# EASTERN CORRIDOR SEGMENTS II AND III (PID 86462) SR 125/SR 32 FOCUS AREA ADVISORY COMMITTEE MEETING NOTES

EASTERN CORRIDOR SEGMENTS II AND III (PID 86462)  
**SR 125/SR 32 FOCUS AREA**  
**ADVISORY COMMITTEE MEETING #1**  
ANDERSON CENTER • FEB. 9, 2018  
9:30 a.m. – 11:30 a.m.

Figure 32-4

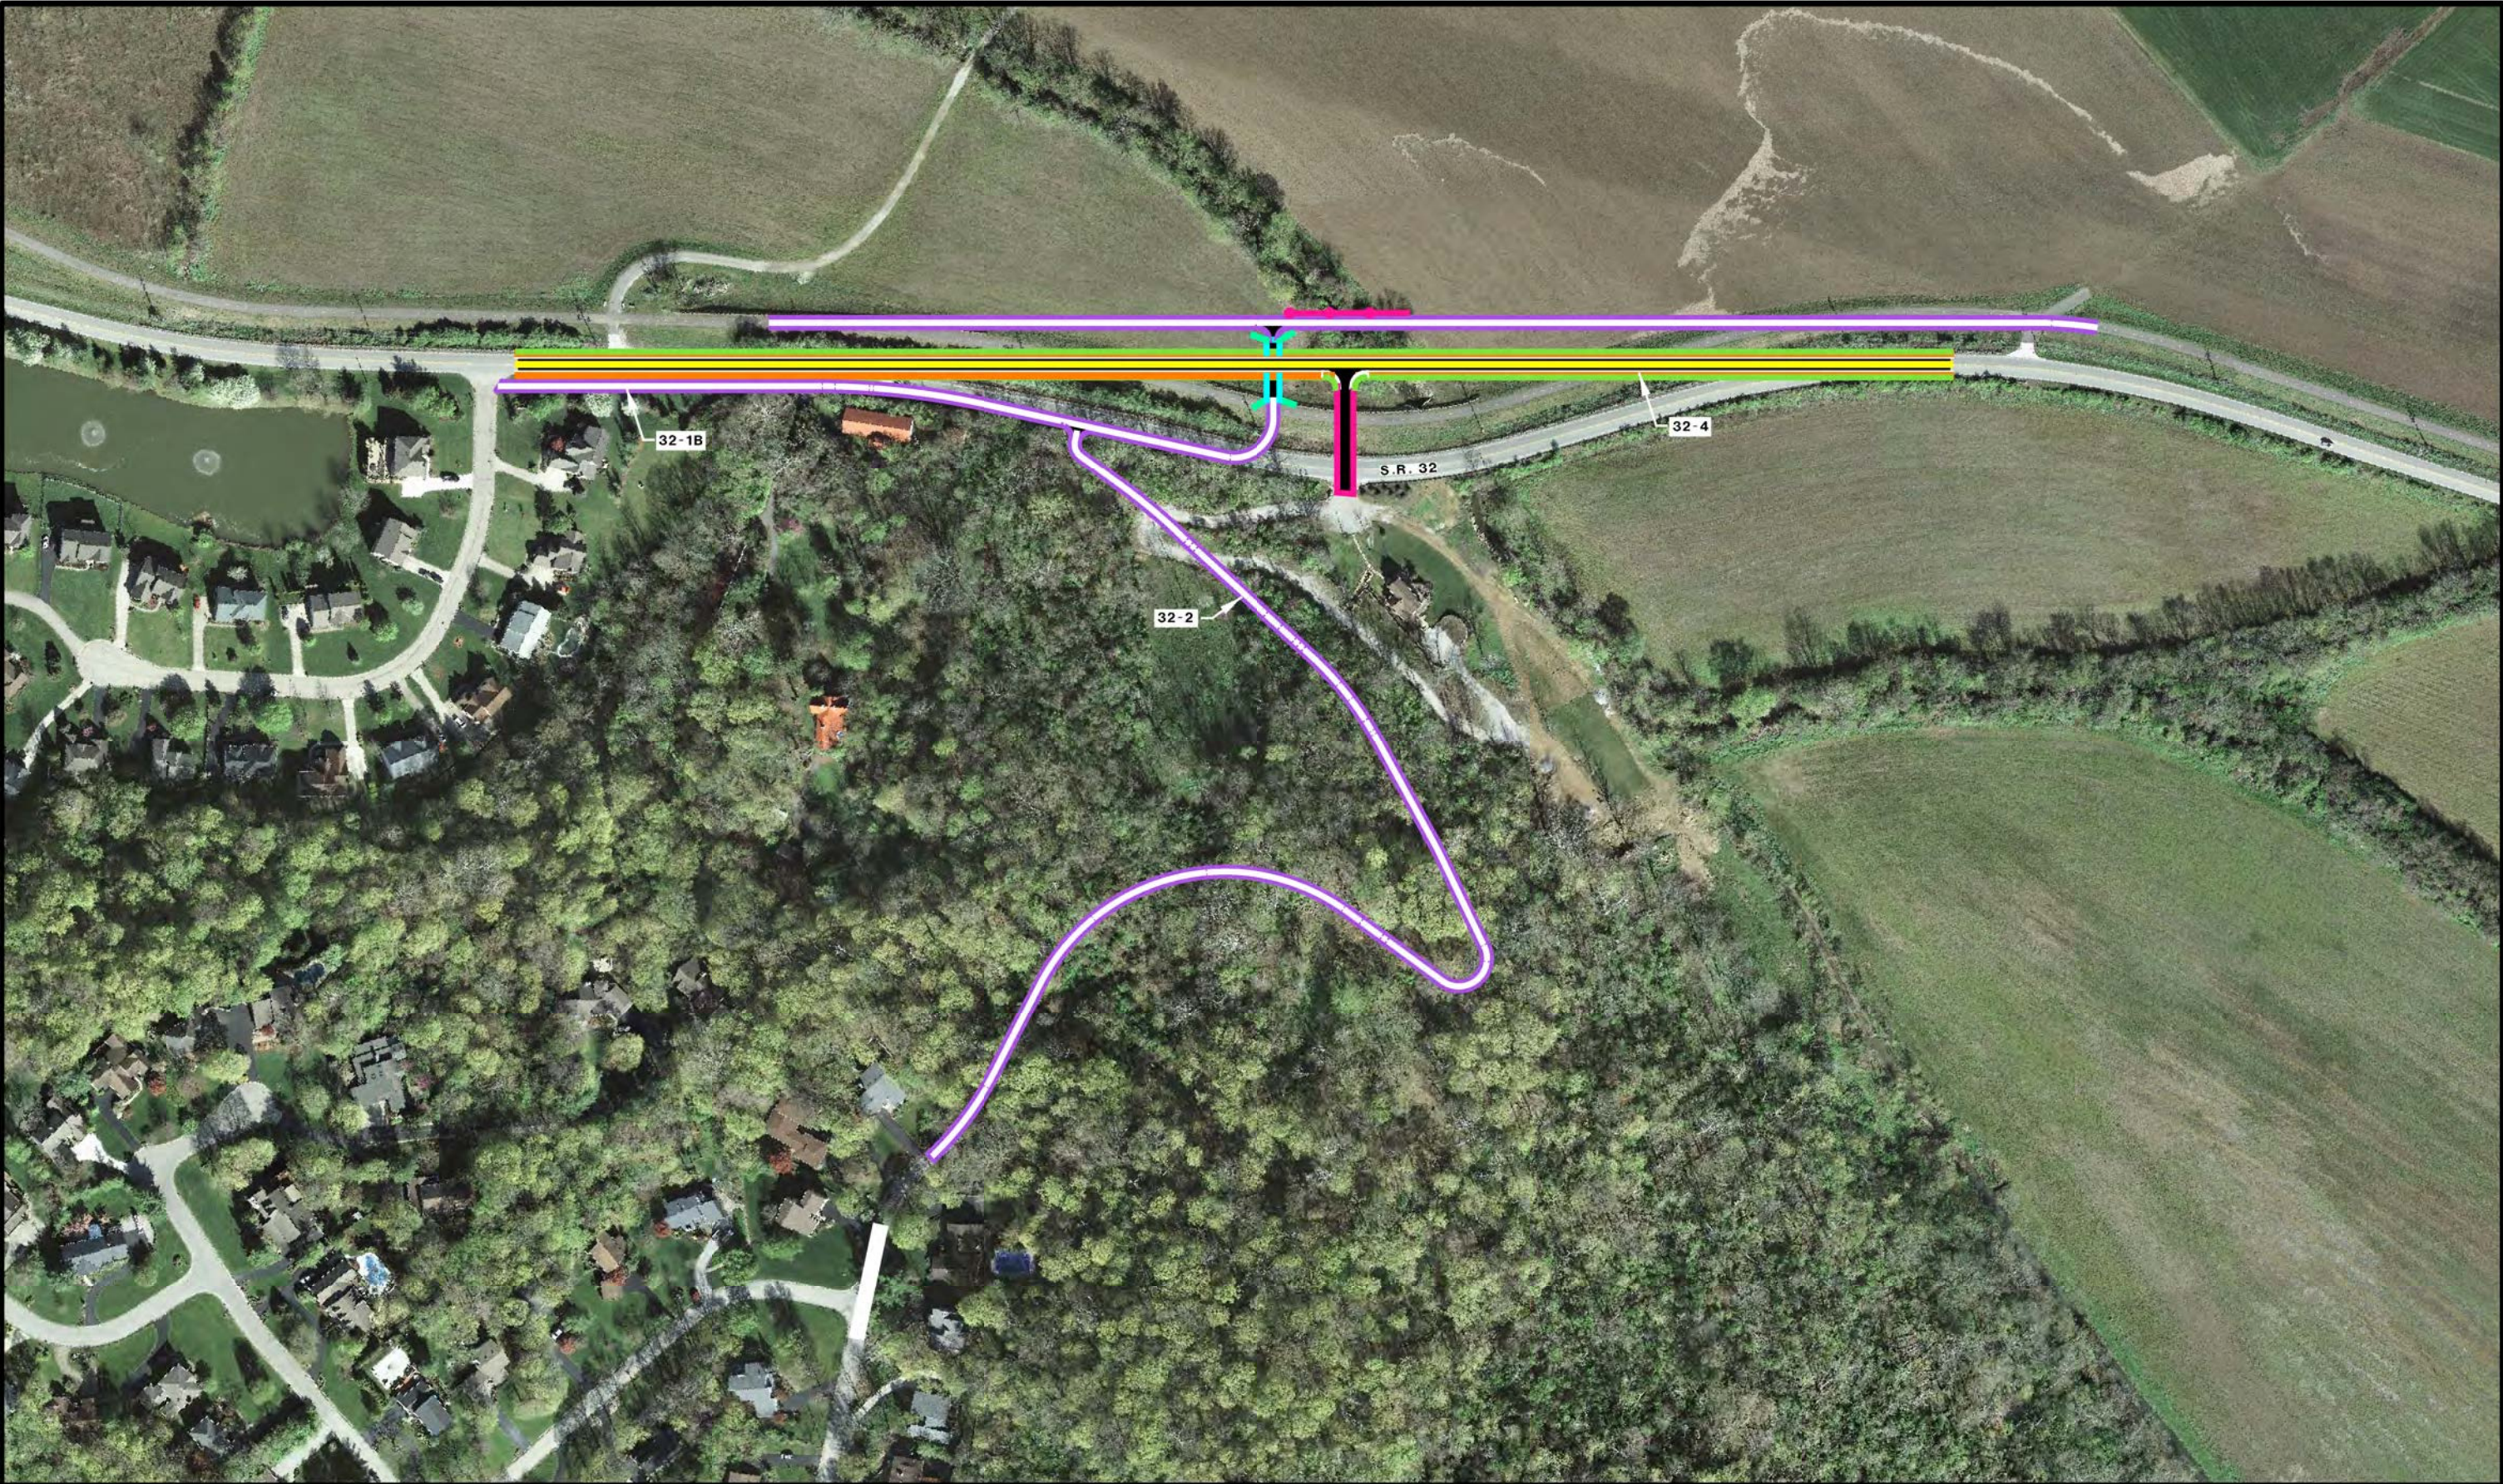
- Public response to this concept tended toward neutral (45%). See Public Feedback Ratings Summary on the next page.
- ODOT noted that as proposed, this concept would address crashes, pedestrian access and flooding issues at this location. However, the committee discussed some concerns regarding the estimated cost of the project.
- Some crashes have occurred in this area, but ODOT has not identified it as an area of particular concern.
- A committee member suggested that costs could be reduced by reducing the speed limit instead of straightening the road. ODOT said a speed study would need to be completed to determine if lowering

the speed limit is warranted. ODOT also noted that the existing curves of the roadway are designed to accommodate a 45 mph speed limit.

- Anderson Township noted that annual flooding in this area and subsequent access (or lack thereof) is of most concern to them; benefits gained from the project may exceed the cost. The committee briefly discussed focusing more on raising the roadway and less on straightening it.

- The committee noted that even if this project were completed and addressed flooding problems at this location, the project would not address other flooding issues throughout the corridor, therefore flooding would remain a problem unless addressed elsewhere too.

- Include in the Implementation Plan as a low priority.
- Investigate option to raise the road to address flooding without correcting the “S” curve.

**Figure I-7B**  
FLYOVER FROM CLOUGH PIKE TO S.R. 32 WESTBOUND  
AND RELOCATED BIKE TRAIL

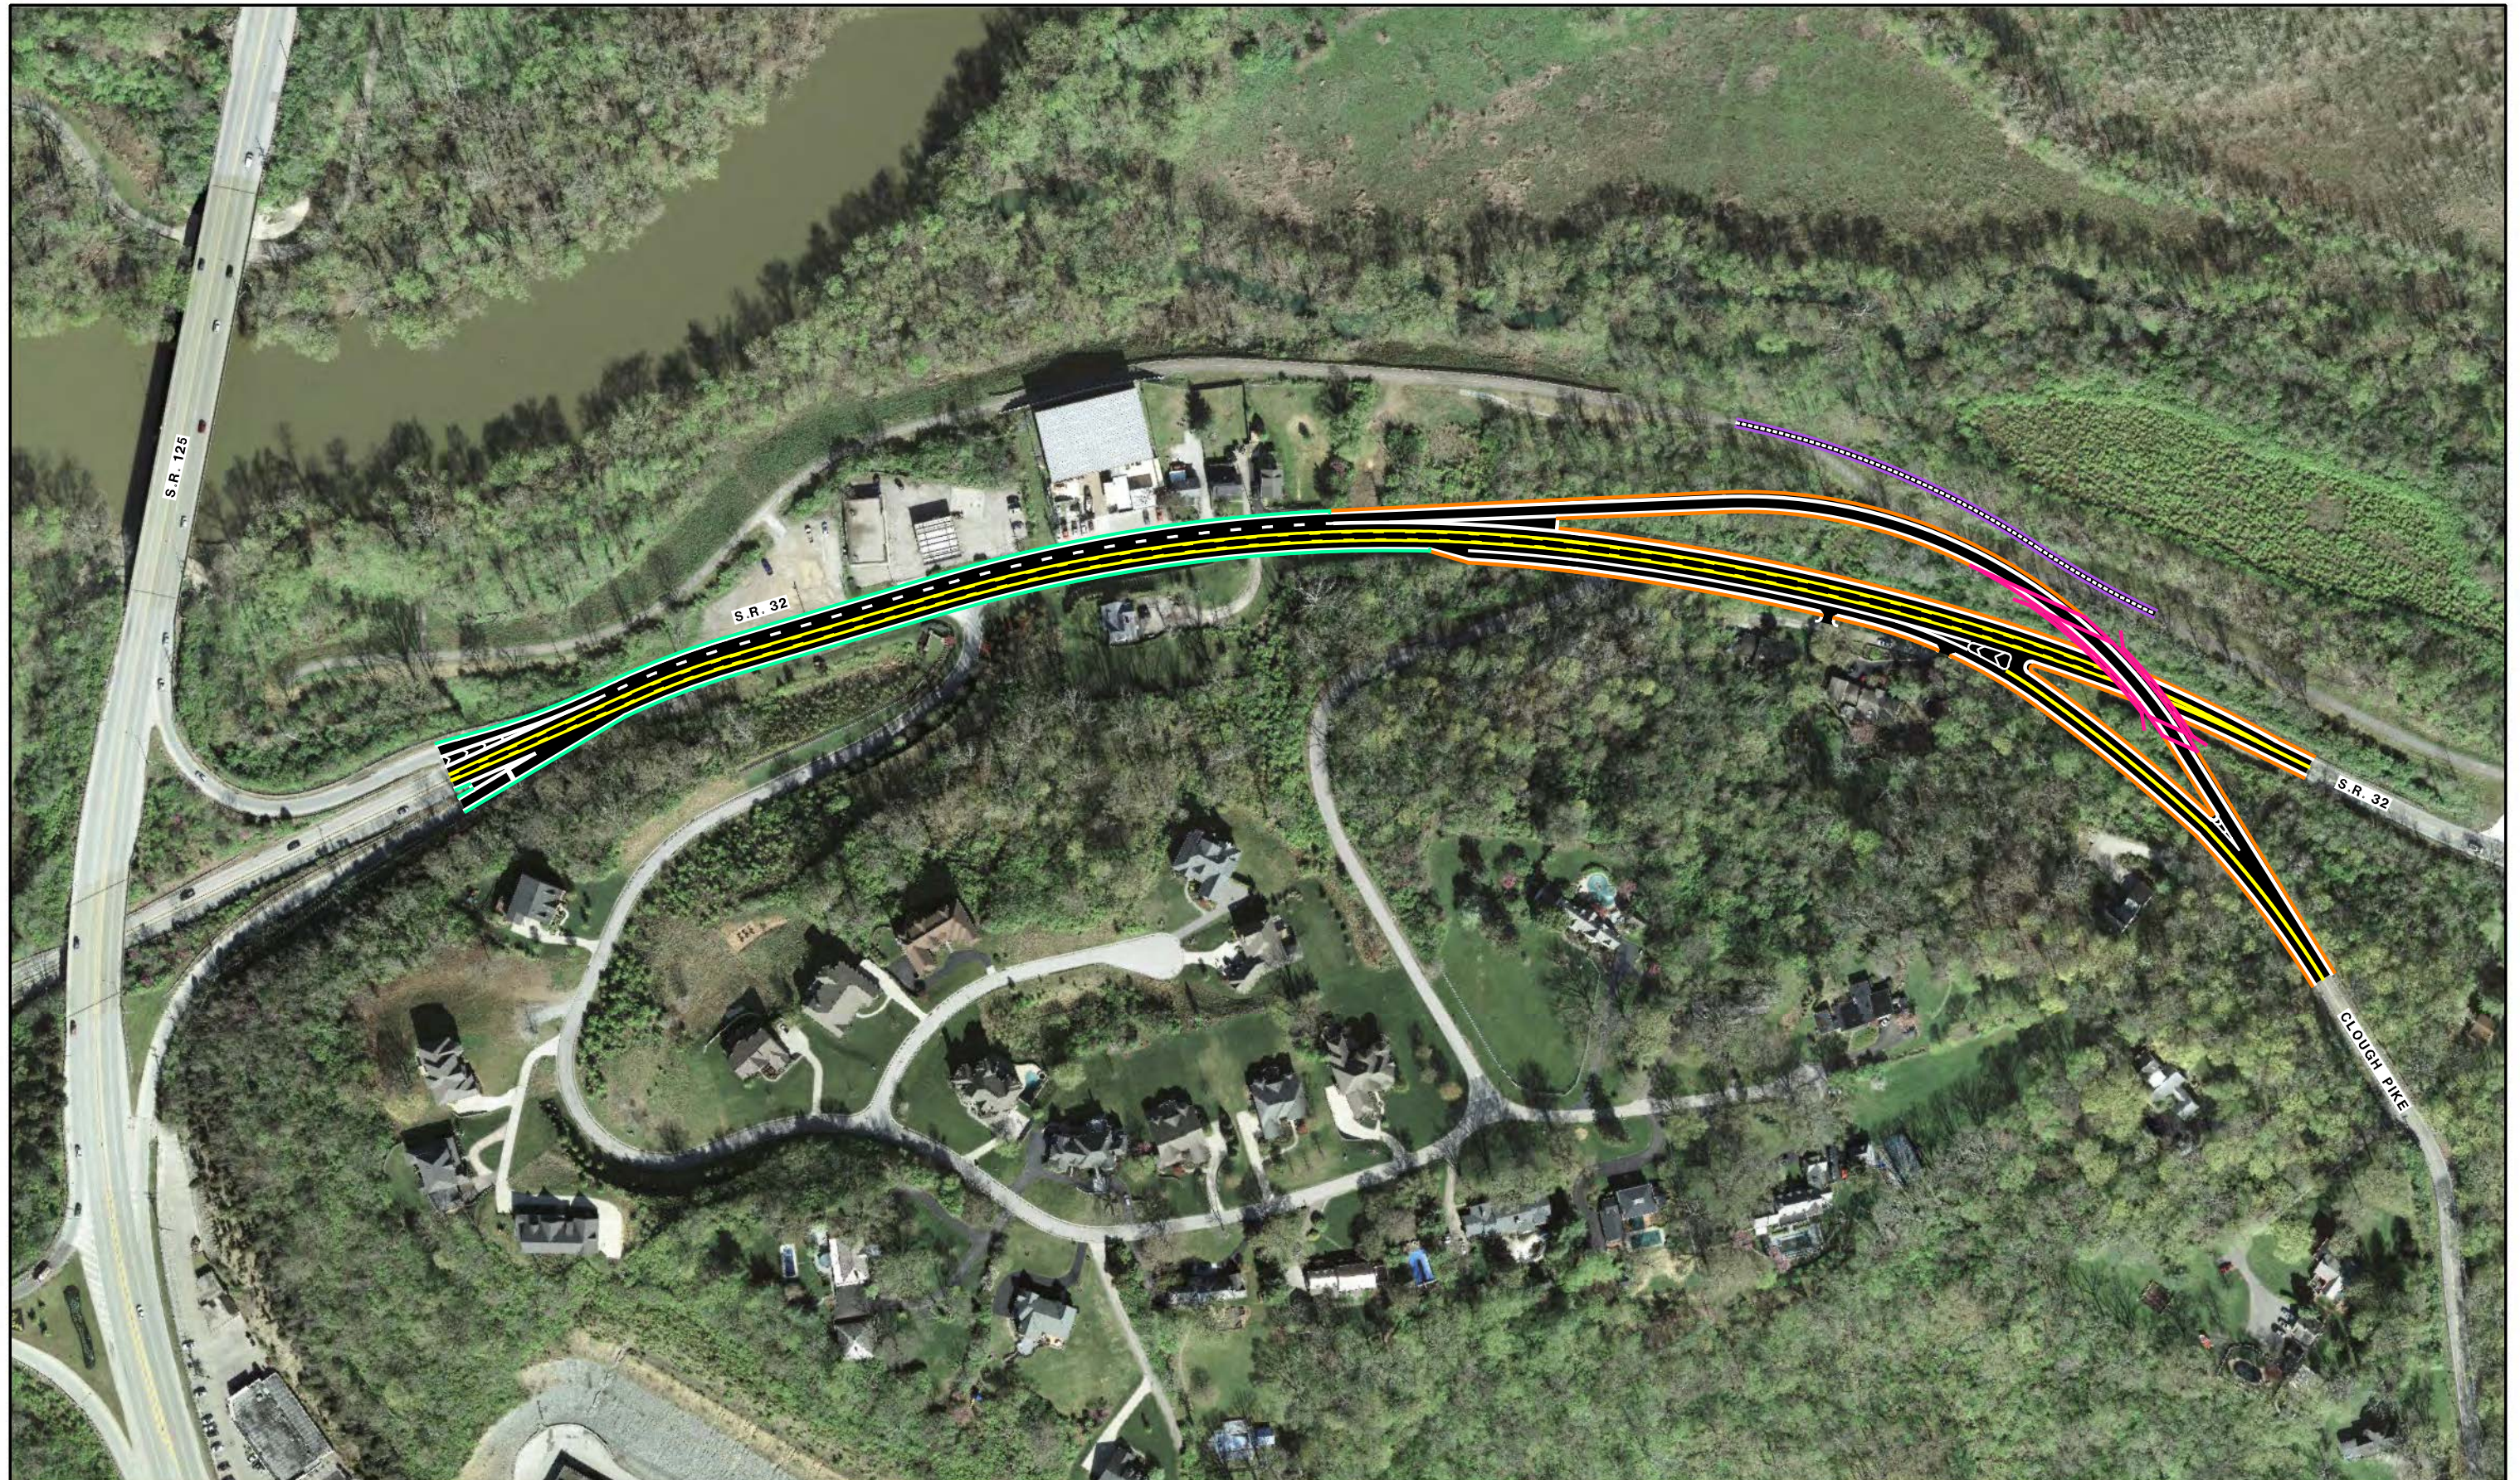
- A flyover would provide a fluid connection from Clough to westbound SR 32.
  - It would eliminate the need for most movements to stop at the SR 32/Clough Pike intersection.
  - It would remove the need for a signal at the intersection, which would reduce delays.
- As drawn, the right turn from Clough to eastbound SR 32 is a very tight turn.
  - Consultant will determine if the turning radius can be improved and/or if a turn signal would be needed.
- Consultant to evaluate:
  - Impact of this concept on traffic flow to and from SR 125/Beechmont Levee.
  - Impact of free-flowing traffic on SR 32.
  - Impact on vehicles entering/exiting the Speedway gas station.
  - Relocation of bike trail.
- No additional comments were received following the 5/24 meeting.

- The Advisory Committee viewed a traffic flow simulation for this concept.
  - Simulation showed that traffic flow improves.
  - No weaving problems are expected.
- No back-ups are expected at SR 32 ramp to SR 125 because entry to SR 125 is free-flowing (no stop lights).
- Estimated construction costs of this concept and the roundabout concept (I-7c) are similar (\$4.5M to \$6.8M for concept I-7b and \$3.8M to \$5.7M for I-7c)
- Concept eliminates traffic signal at intersection.
- Concept doesn’t provide a left turn option from SR 32 to Clough. However, that movement is not permitted today.
- No additional comments were received following the 8/20 meeting.

- No further study:
  - Concept I-7d achieves the same benefits at a markedly lower cost.
  - Concept I-7d adds the ability to turn left from westbound SR 32 to Clough.
  - The benefit/cost ratio is lower than concepts I-7c and I-7d.
